**Figure 1 – Location of Mystic River Outfalls Described in Comment 78**

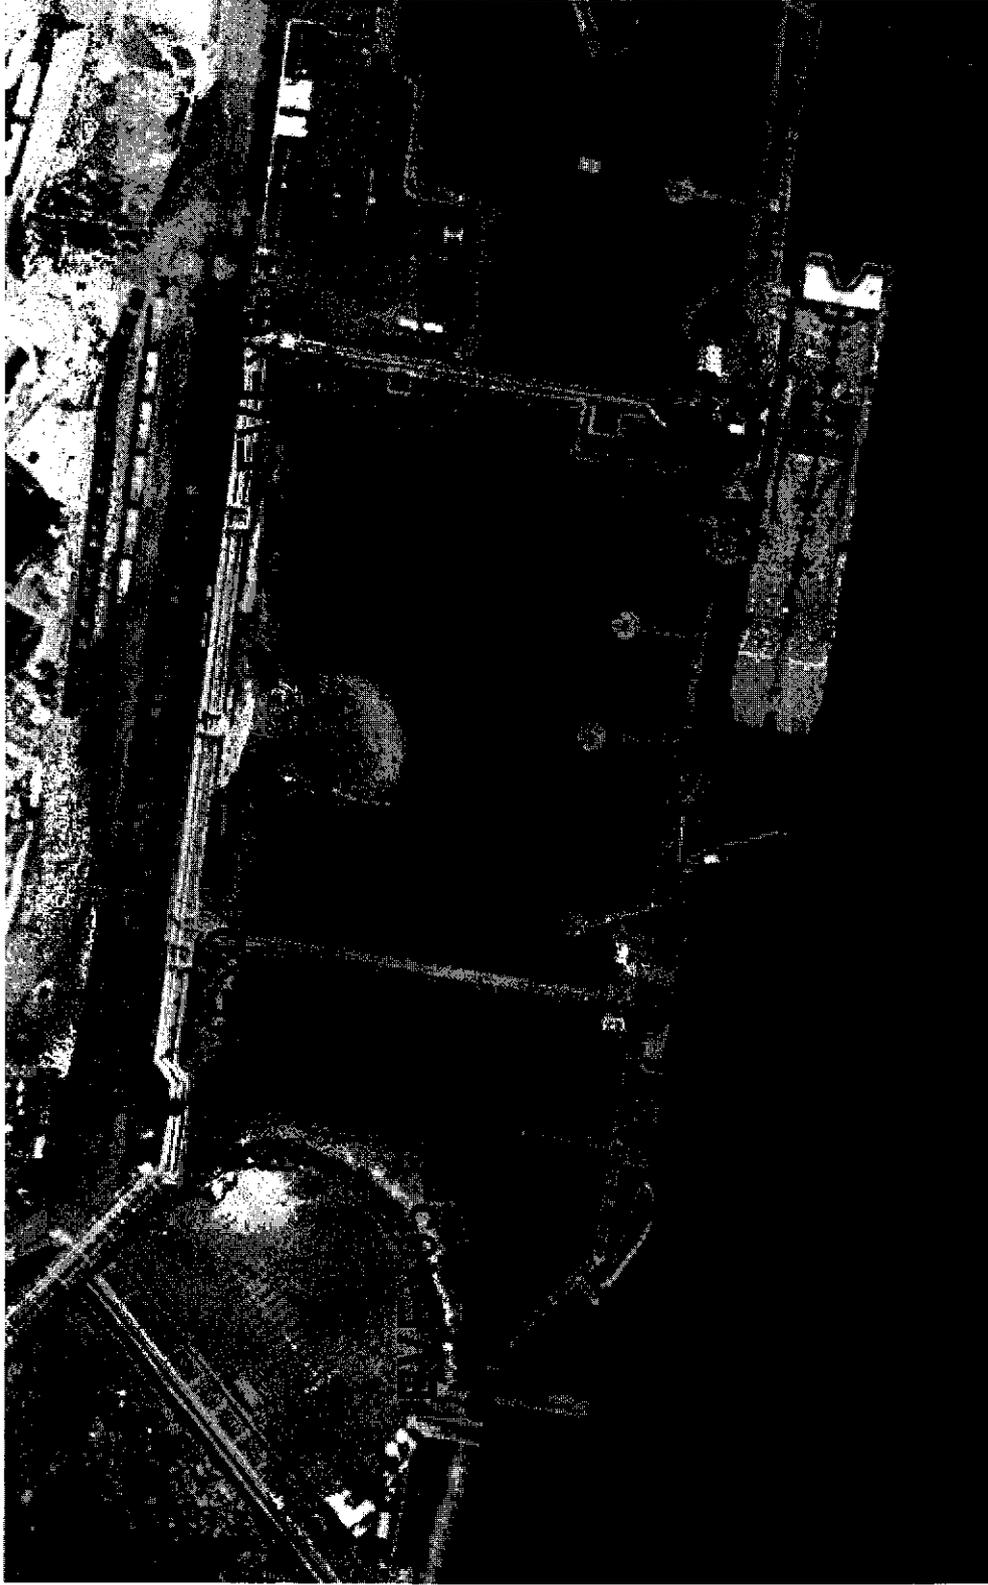
**Again, thank you for this opportunity to comment. I believe the new permit could go a long way towards making the Island End River more ecologically sound.**

Outfalls EEx03, EEx04, and EEx05, as identified on the photo attached to the comment letter (see Attachment C), are not owned by ExxonMobil and are not covered by NPDES permit MA0000833 and, therefore, are beyond the scope of this response to comments.
